ENGINE - FUEL AND CONTROL - REPLACE THE TUBE CLIP AT CLIPPING POINT 0795 - CATEGORY
CODE 4 - MOD.ENG-73-0060

V2500-ENG-73-0060

SERVICE BULLETIN

Location at clipping point 0795
Fig.1

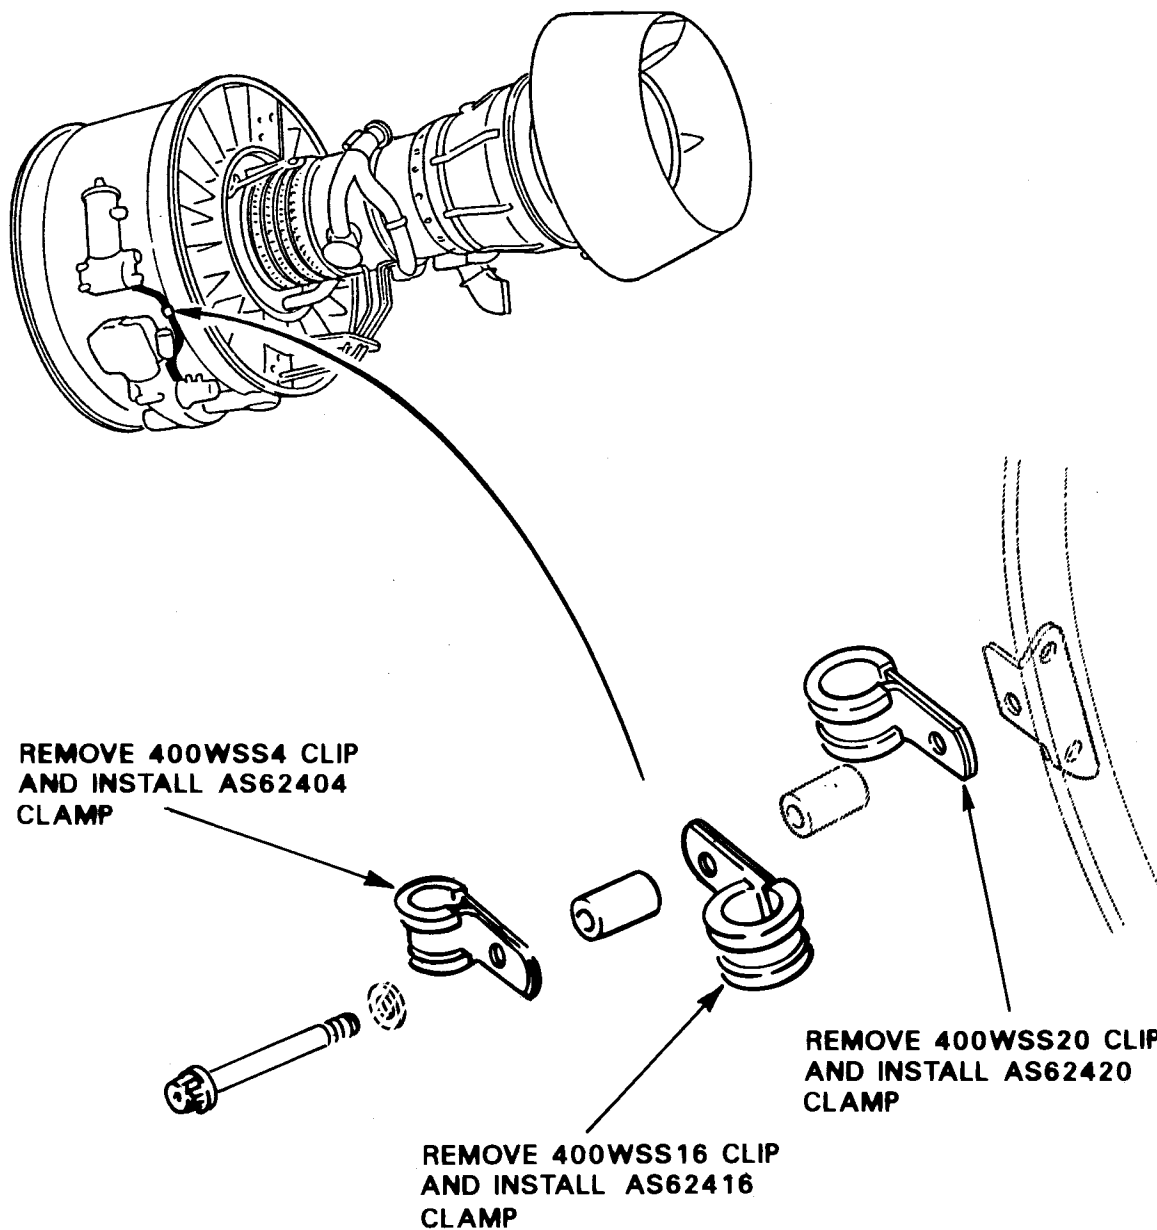
- (1) Remove the bolt AS20940, the washer K8831, the two spacers UP10481 and UP10482 from clipping point 0795. Refer to Figure 1.
- (2) Remove clips 400WSS4, 400WSS16 and 400WSS20.
- (3) Discard clips.

View of clipping point 0795 - Before and after alteration
Fig.2

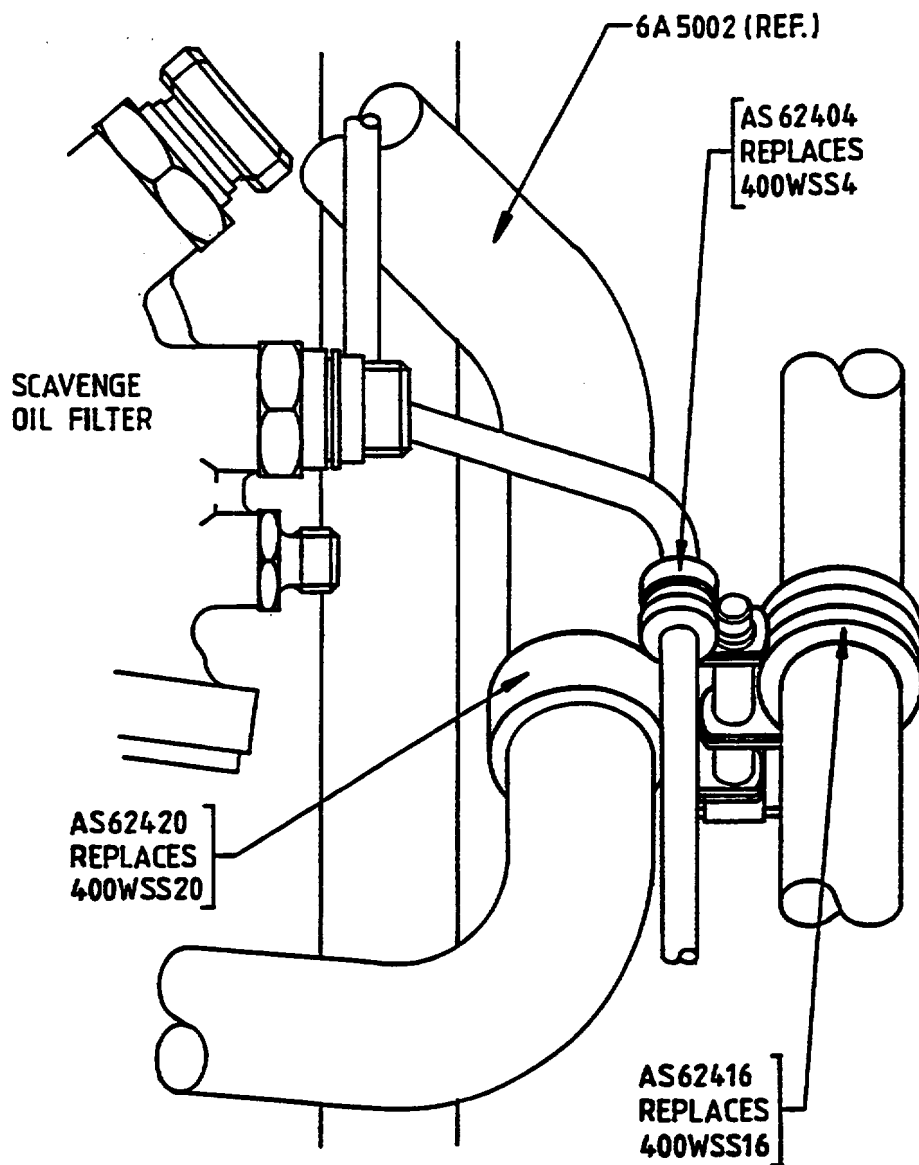
- (a) Tube clamps with a thicker rubber sleeve replace the existing clips at clipping point 0795. The new clamps have a tighter fit with the tube compared to the existing clips.

- (1) Secure the F.C.O.C. to fuel pump fuel tube to clipping point 0795 using clamps AS62404, AS62416, bolt AS20940, washer K8831, spacers UP10481 and UP10482. Torque the bolt to 36 to 45 lbf·in (4 to 5 Nm). Refer to Figures 1 and 2.
